# SERVICE BULLETIN

No. 280

Case leakage of R. C. Allen 3" Artificial Horizon  
(See attached R. C. Allen Inc., Service Bulletin No. 1.)

SERVICE BULLETIN  
FOR  
ARTIFICIAL HORIZON  
MODEL RCA 21

Figure 1. Application of Pressure Sensitive Tape.

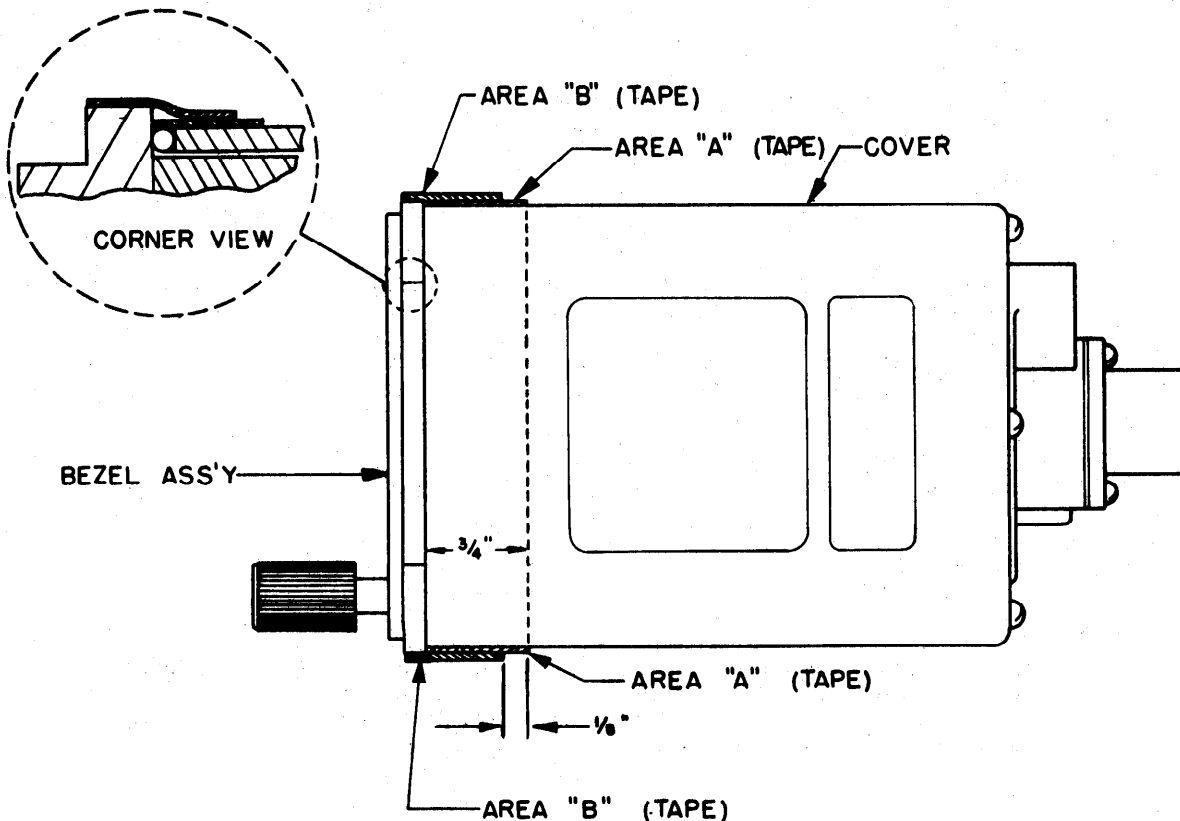
Some deterioration of the gasket used to seal the case to the bezel has been experienced. Such deterioration may occur due to the action of ozone and/or the action of certain solvents to which the gasket may have been exposed. If not corrected, the deterioration may result in leaks which can lead to reduction of vacuum system pressure, sluggish horizon performance and eventually complete failure of the gyro system.

In order to protect the gasket from deterioration and to provide a back-up seal, it is recommended that the procedure described herein be accomplished within the next 25 hours of operation of the aircraft. If reduced vacuum gage readings or sluggish performance of the horizon is noted, inspect for gasket failure immediately.

2. Refer to Figure 1 and apply one wrap of pressure sensitive tape, 3/4 inch wide, around the horizon as shown in Area "A". Pull the tape as it is being applied so that a slight amount of stretching occurs. The edge of the tape must butt against the rear surface of the bezel assembly and lay firmly against the cover. Overlap the tape approximately two inches.

3. Again refer to Figure 1 and apply one additional wrap of the tape over that just applied as shown in Area "B". Apply this wrapping so that the edge of the tape is flush with the front surface of the bezel assembly. Stretch as required so that the tape lays smoothly around the irregular corners of the bezel. Overlap the tape approximately two inches.
